TITLE: New Feedback Card-4		REV: 2.0
Date: 2017-12-02	Sheet: 1/1	
EasyEDA V4.7.8		Drawn By: HAIM SHLAGMAN

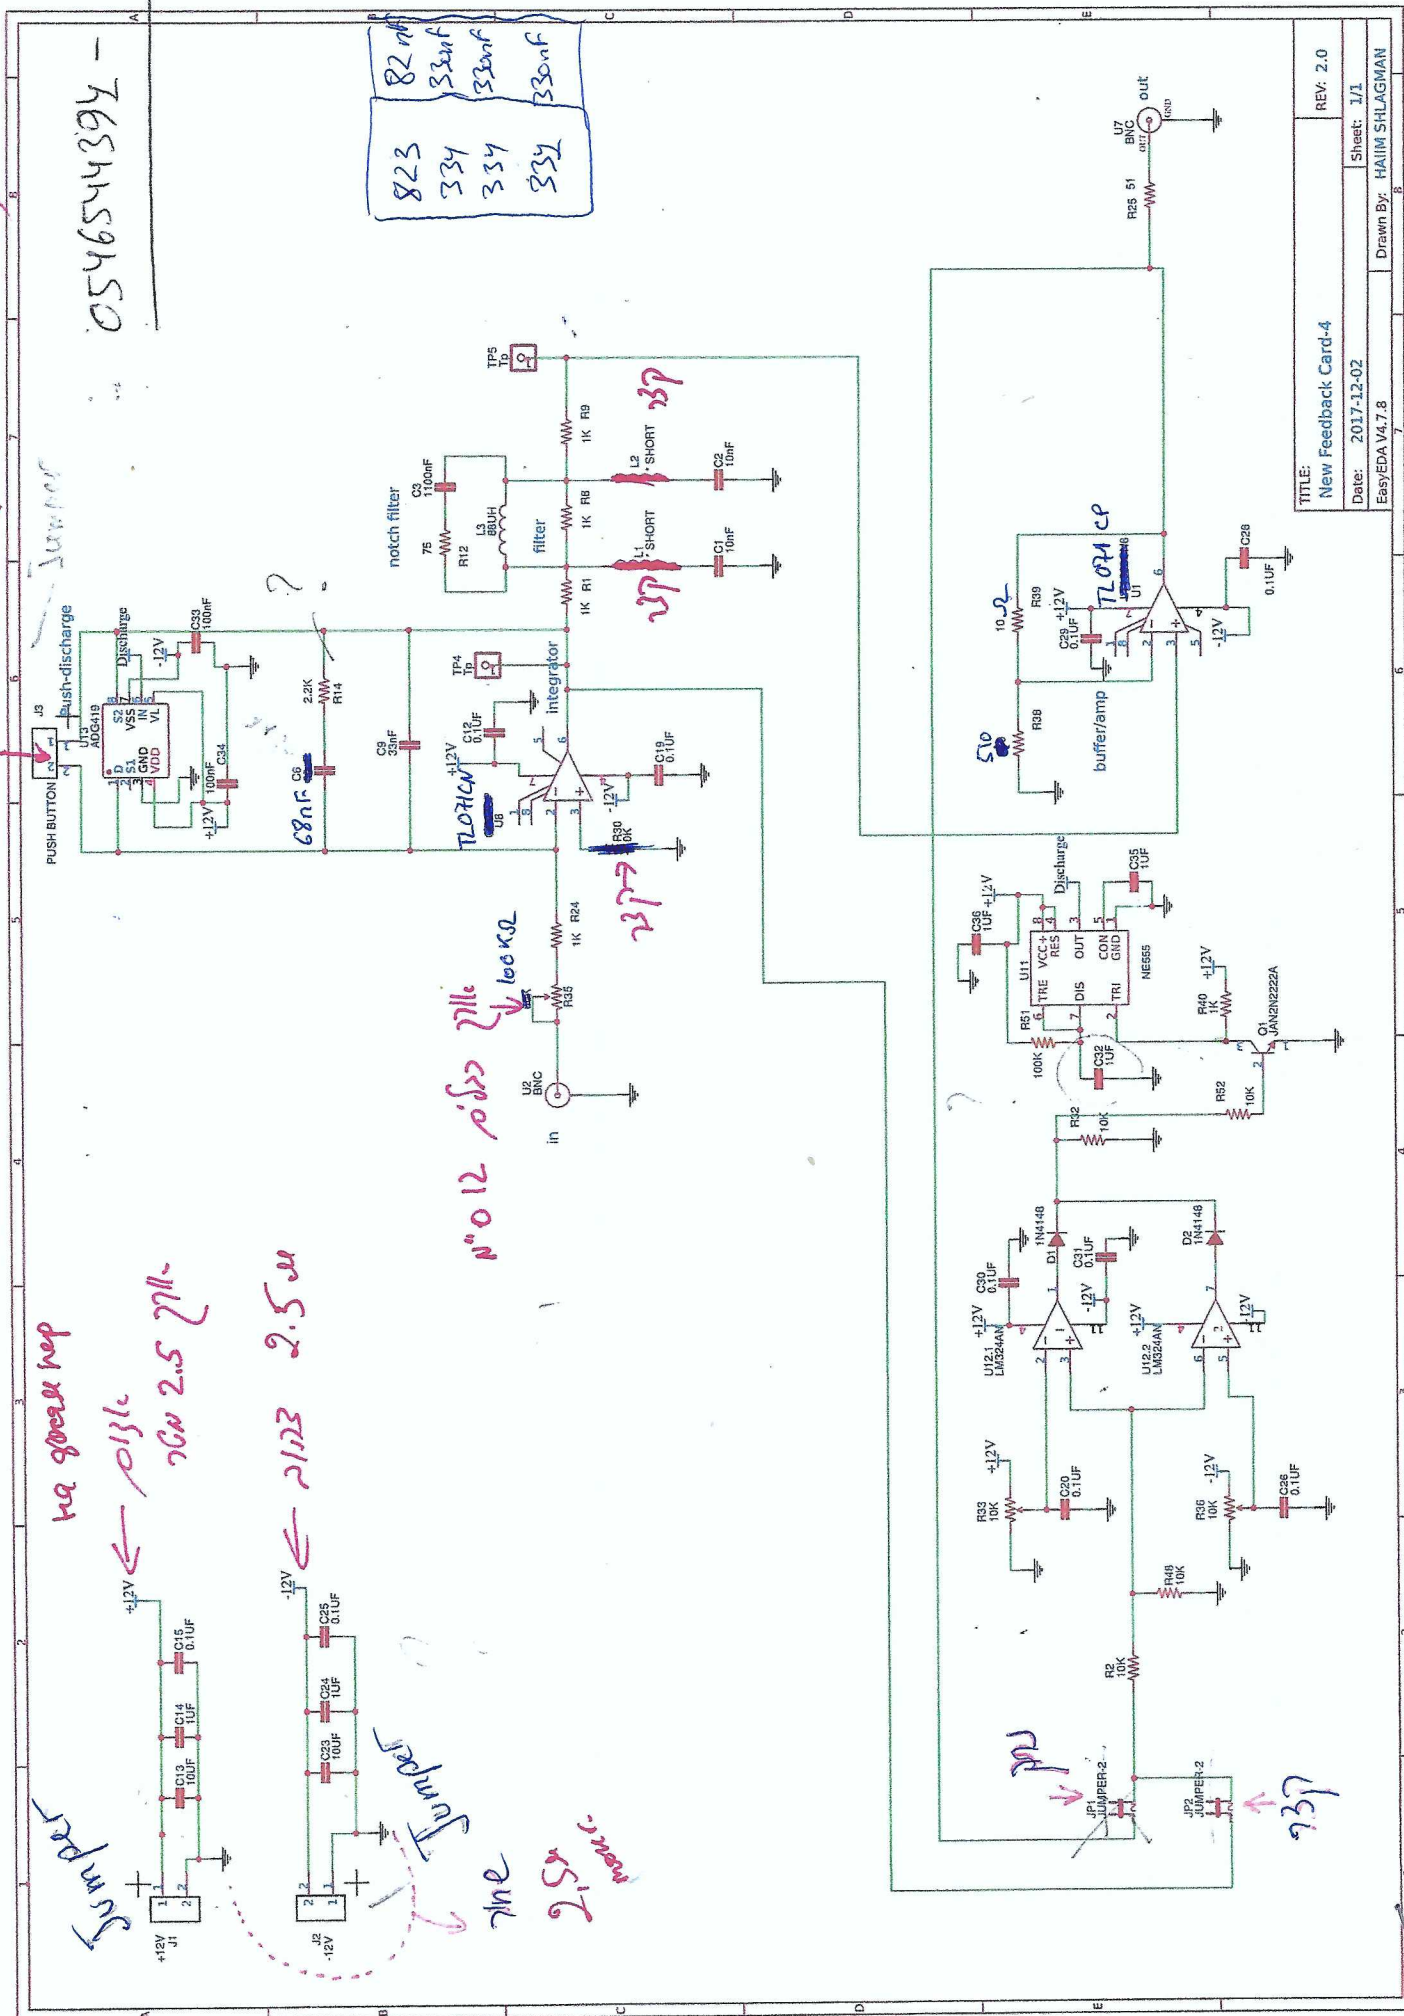
OPEN (NOTHING CONNECT)

jumpers
no good rep
← 013k
76u 2.5 711-
← 2123 2.5u

no 012 pots 711k
↓ 100kΩ

jumpers
no
2.5k
2.5u
